REVISION HISTORY

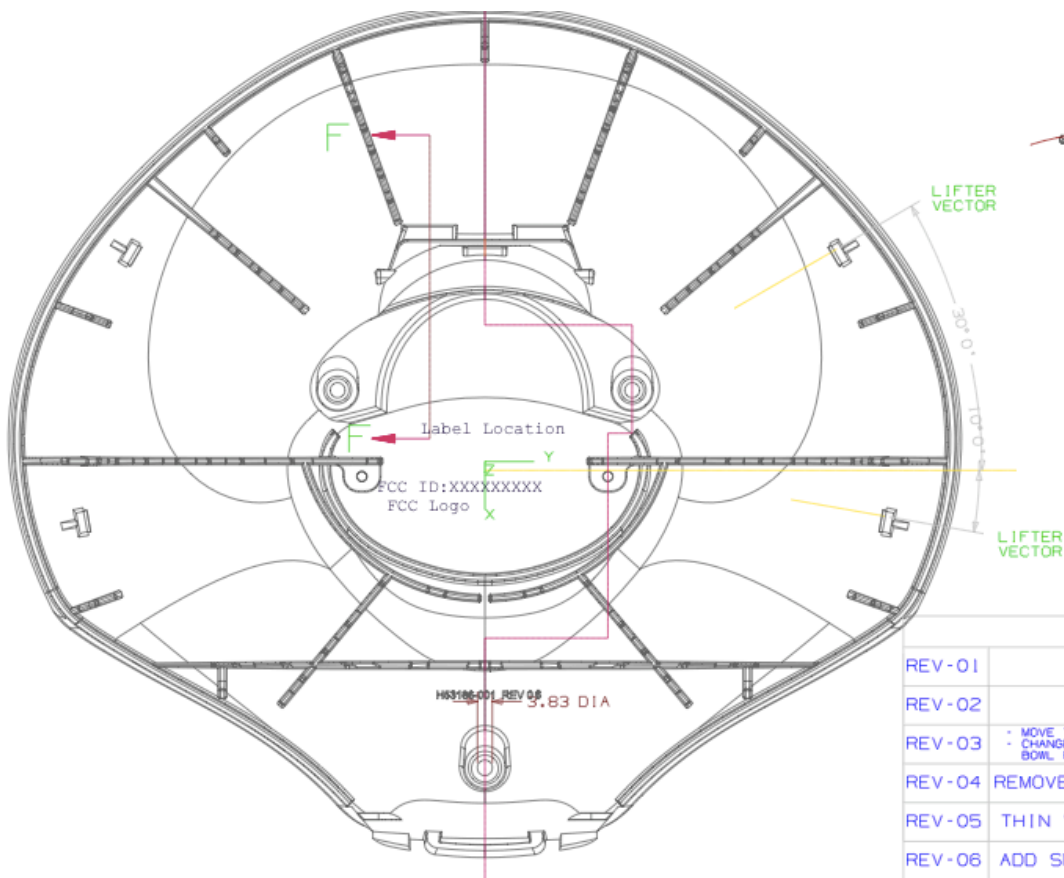
REV-01	RELEASE FOR DFM	8-22-14
REV-02	CHANGE TEXTURE	8-28-14
REV-03	- MOVE TOP OF USB +Z 0.1MM - CHANGE 4 SNAP HOOKS TO FIT BOWL REV 3 MOD.	9-03-14
REV-04	REMOVE HEATSINK CENTERING TAB	9-11-14
REV-05	THIN WALLS AROUND USB3 PORTS	11-13-14
REV-06	ADD SNAP POCKET FOR FRONT FOOT	11-19-14
